PROPOSED CAMBOURNE TO CAMBRIDGE BUSWAY – BIN BROOK CROSSING AND IMPACT ON CLARE HALL

Acoustics Proof of Evidence

Document Reference: JDB/VL/P24-3220/11

Date: August 2025

Figure 3.1: Excerpt of Proposed Site Plan⁹ (Sheet 17 of 17) Showing the Welfare Unit in Dark Blue, the Brian Pippard Accommodation building in Magenta, Clare Hall Accommodation Building in Cyan and the Main Clare Hall Building in Yellow

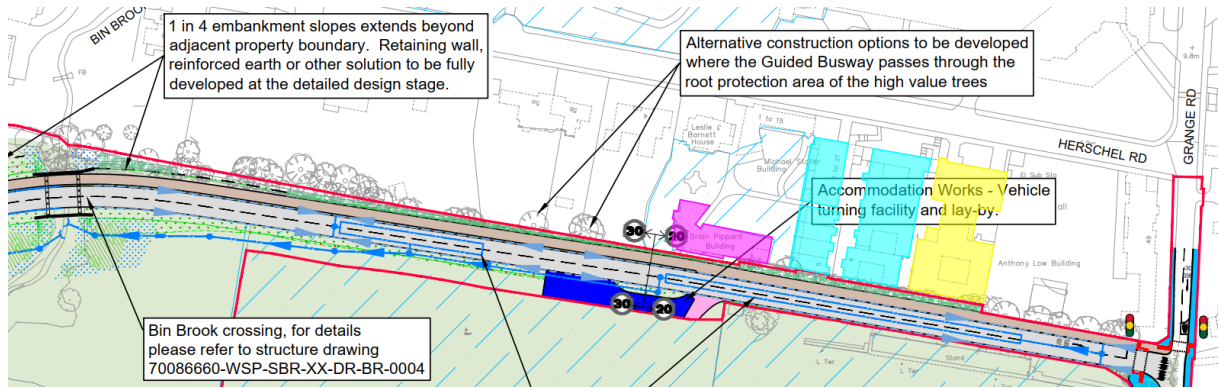
- 7.24 The proposed site plan²⁷, previously submitted, shows the only Accommodation Works for the entire works compound will be situated outside the Brian Pippard building. Once installed in this location, this area will be used for vehicles as a turning point, but could also be used to store the plant and equipment. In my experience, these areas usually include a diesel generator for power to the welfare cabins and manned security cabin. Generators for the security cabins would most likely run continuously through the day and nighttime hours. I assume that once the Accommodation Works have been installed, this area would be used on a daily basis for the duration of the works, especially as this appears to be the only site accommodation along the entire route.

Figure 6.1: Excerpt of Plate T1-2-1 Noise Monitor Locations From WSP Report CD1-11.01

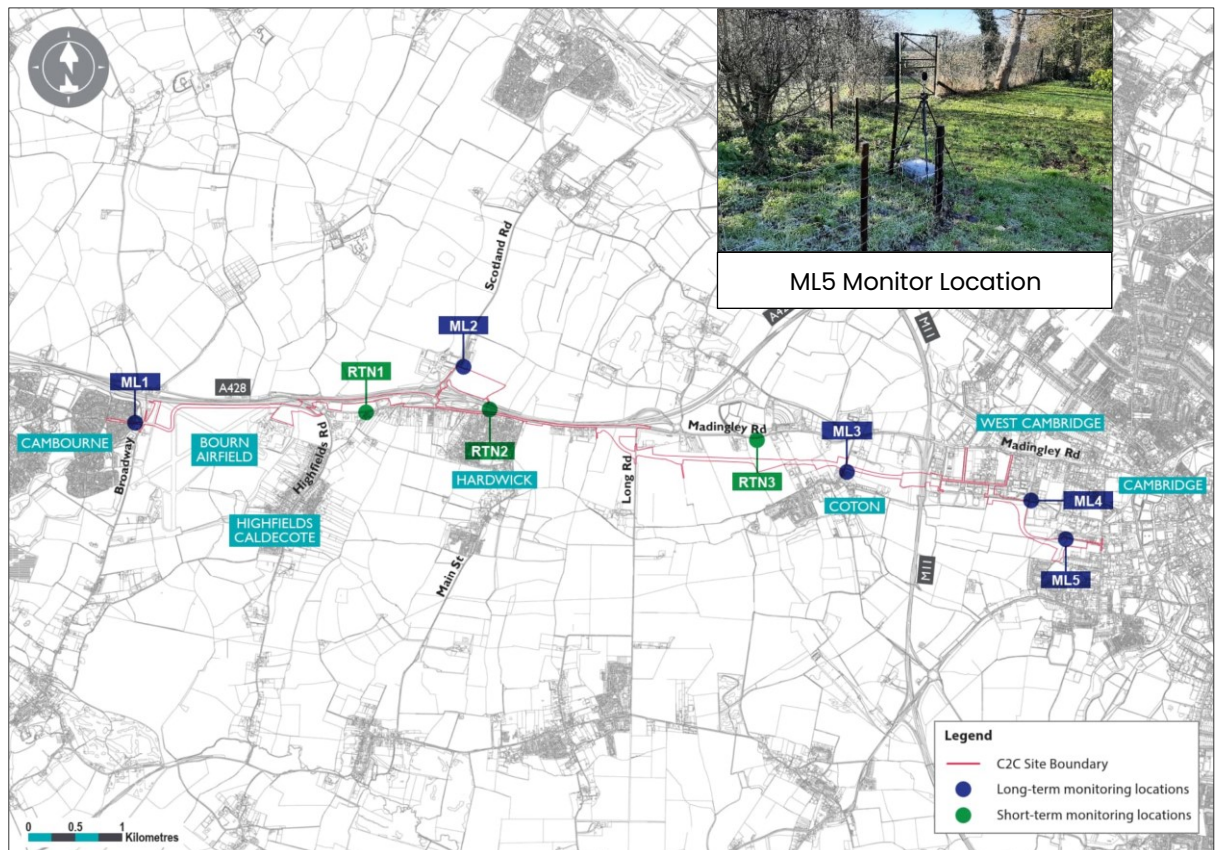
- 6.2 The only location relevant to Clare Hall was ML5, which was in the south garden of 9 Herschel Road. This property is part of the student accommodation provided by Clare Hall of the campus, but is not within the main area of Clare Hall. The monitoring location was close to the existing bridge over Bin Brook. For reference, ML5 was approximately 200m west of the Brian Pippard Building.

Figure 7.2: Excerpt of TR1-5-3 Showing the Omitted Sensitive Receptors by Green Dashed Line

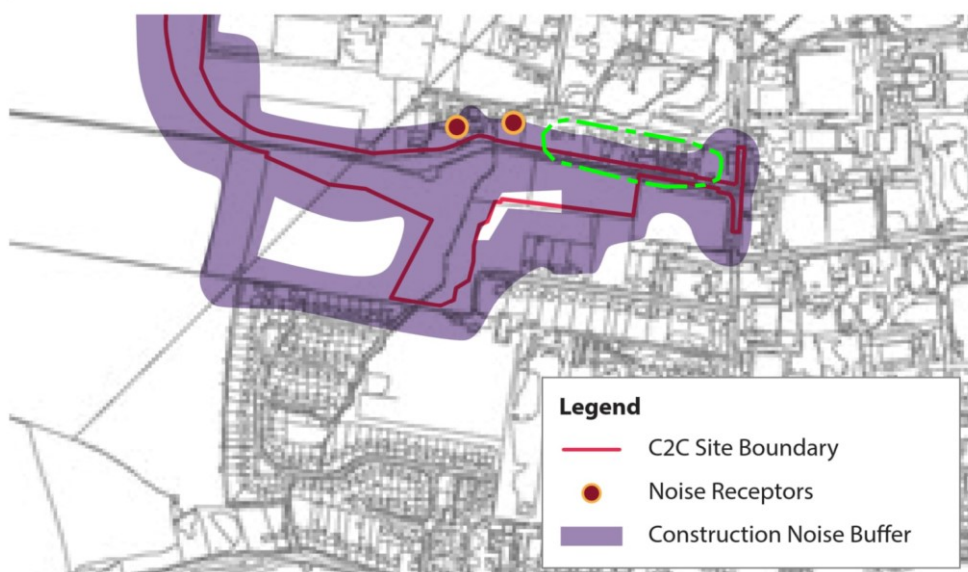
- 7.3 An excerpt of TR1-5-3 from CD1-11.01 has been included in Figure 7.2, with the remainder of the accommodation units surrounded by the green section, which I have overlaid.

- 7.4 The purple 40m Construction Noise Buffer that WSP have proposed, defines the area of predicted significant noise effect. It can be seen that this will include the vast majority of the accommodation units within the Clare Hall campus, including the Brian Pippard building, Clare Hall accommodation and the main Clare Hall Building.

Figure 7.3: Image Showing The Omitted Sensitive Receptors Shown in Green Area of Figure 7.2

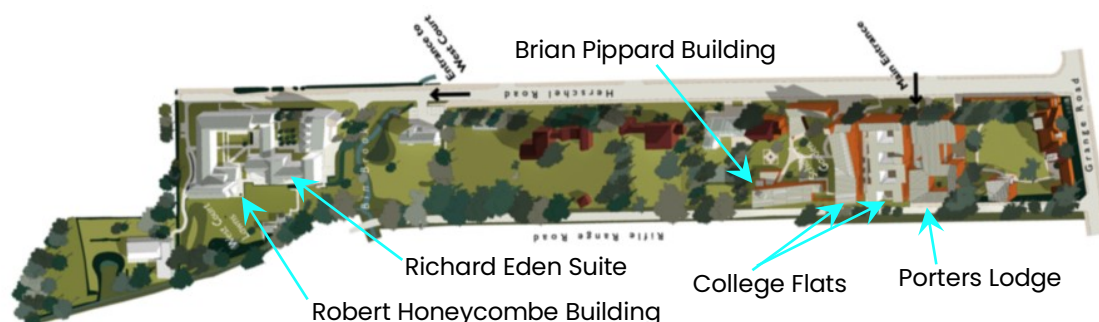
- 7.5 These additional buildings should have been considered as sensitive as they are either residential dwellings or places of research and study where concentration is of paramount importance.

Figure 7.4: Excerpt of 70086660-WSP-SBR-XX-DR-BR-0004 Rev P04 Showing Width of the Proposed Bin Brook Bridge

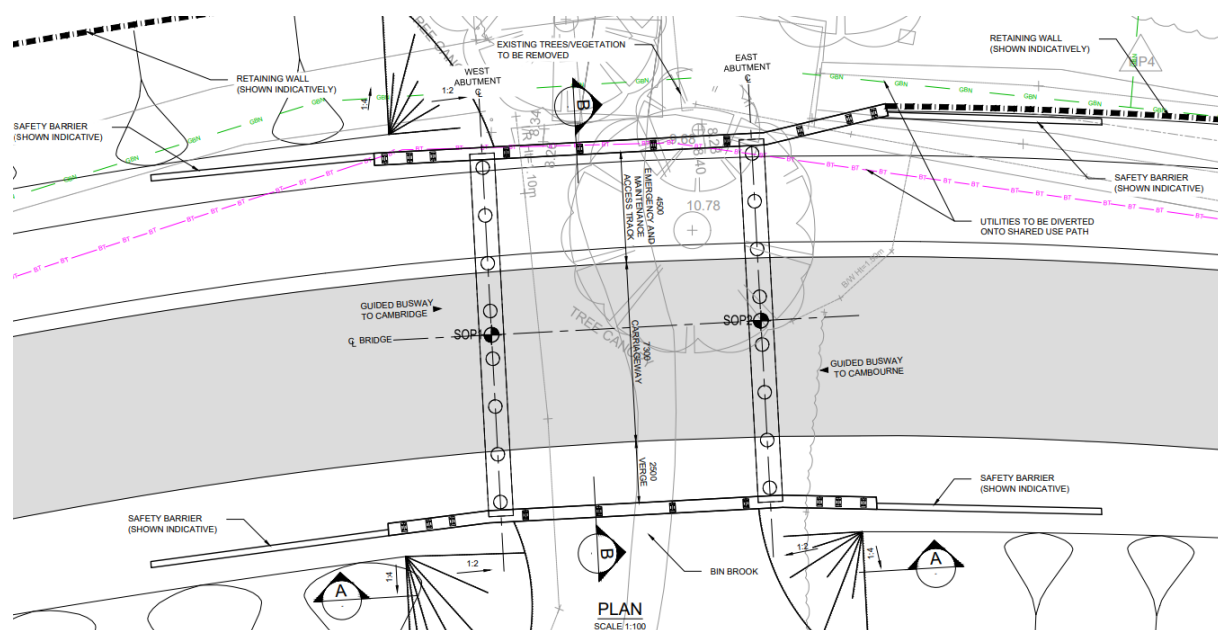
- 7.34 The distance from the centre of the existing bridge to the Gillian Beer Building is approximately 30m, so for the proposed 14.3m wide bridge, the distance from the periphery of the bridge construction site would be approximately 23m, assuming the same centre line for both the existing and proposed waterway crossings.
- 7.35 From my personal experience, I have assumed that the following plant and equipment could be required for the bridge construction;

Figure 9.1: Excerpt of Drawing 70086660-WSP-HGN-XX-DR-HW-002017 (Sheet 17 of 17) with the Scaled Dimension of 6.88m from Edge of Guided Busway to Clare Hall

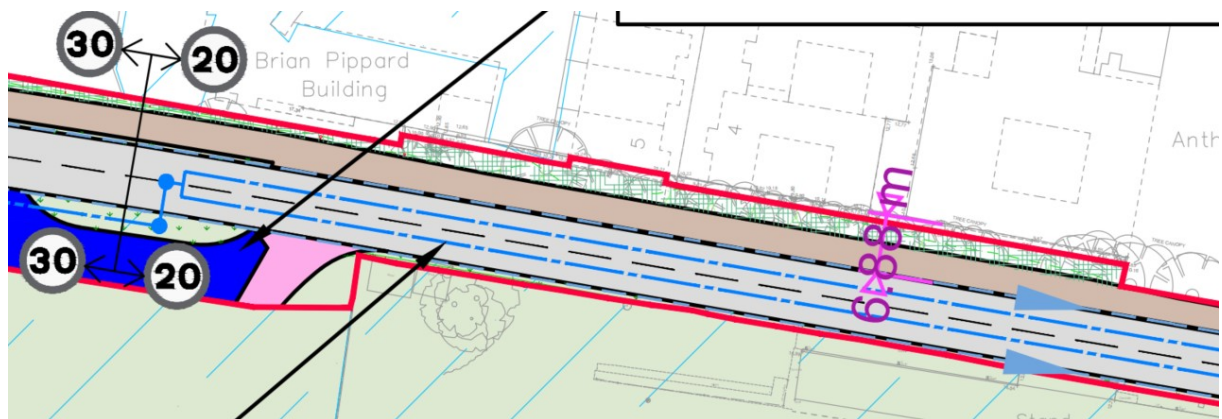
- 9.10 As can be seen in Figure 9.1, the distance from the edge of the guided busway has been measured to be approximately 7m from the various façades of Clare Hall and the Brian Pippard Building.

- 9.11 Using the SEL of 74 dB(A) from paragraph 5.30, the noise model created by Create Consulting has predicted that the resultant sound level from the guided busway at the façades of the Brian Pippard Building and Clare Hall would be approximately **56 dB $L_{Aeq,1h}$** at a distance of 7m.
